Access Compliance Report

Public Rights-of-Way

Intersection ID: 8512	Main Street: ISENHOUR_ST	Cross Street: MCARTHUR_AV	Location: SW
ADA ID: 338DEE0B304C	Ramp Type: Perp	Initial Pass/Fail: Fail	Overall Compliance: No
		Severity Score: 35

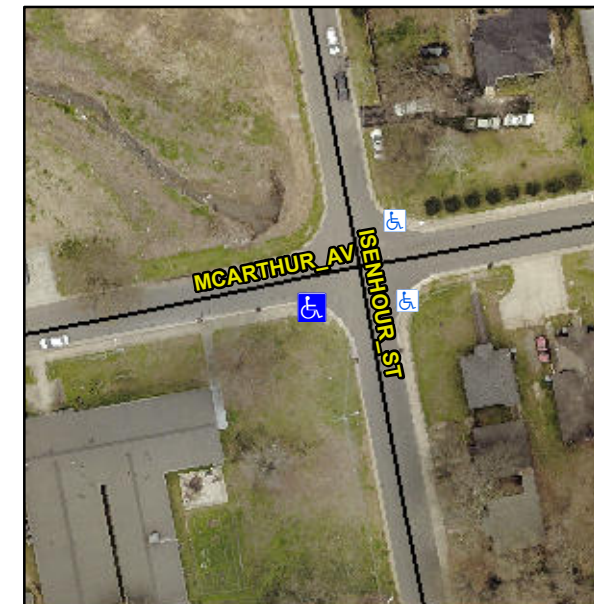
Not Found, R304.5.1, R304.2.2, R304.5.3

Compliance	Description	Data	Compliance	Description	Data
N/A	Ramp Length (in)	60.5	No	Ramp Slope (%)	13.4
No	Ramp Width (in)	37.0	No	Ramp XSlope (%)	3.2
N/A	Flare Type LT	N/A	N/A	Flare Type RT	N/A
N/A	Flare Slope LT (%)	N/A	N/A	Flare Slope RT (%)	N/A
N/A	Flare Traversable LT?	N/A	N/A	Flare Traversable RT?	N/A
N/A	Landing Length (in)	N/A	N/A	DWS Provided?	N/A
N/A	Landing Width (in)	N/A	N/A	DWS Contrast?	N/A
N/A	Landing Slope (%)	N/A	N/A	DWS Length (in)	N/A
N/A	Landing X Slope (%)	N/A	N/A	DWS Full Width?	N/A
N/A	Landing Curb? (Y/N)	N/A	N/A	DWS Offset (in)	N/A
N/A	Shared Landing?	N/A			
N/A	Gutter Ponding?	N/A	N/A	Gutter Slope (%)	N/A
N/A	Gutter Lip Ht (in)	N/A	N/A	Gutter X Slope (%)	N/A
N/A	Painted X Walk1?	No	N/A	Painted X Walk2?	N/A
	X Walk 1 Direction	To E		X Walk 2 Direction	N/A
N/A	X Walk 1 Width (in)	N/A	N/A	X Walk 2 Width (in)	N/A
	X Walk 1 Slope (%)	2.8		X Walk 2 Slope (%)	N/A
	X Walk 1 X Slope (%)	1.0		X Walk 2 X Slope (%)	N/A

Remove & Replace Entire Ramp.
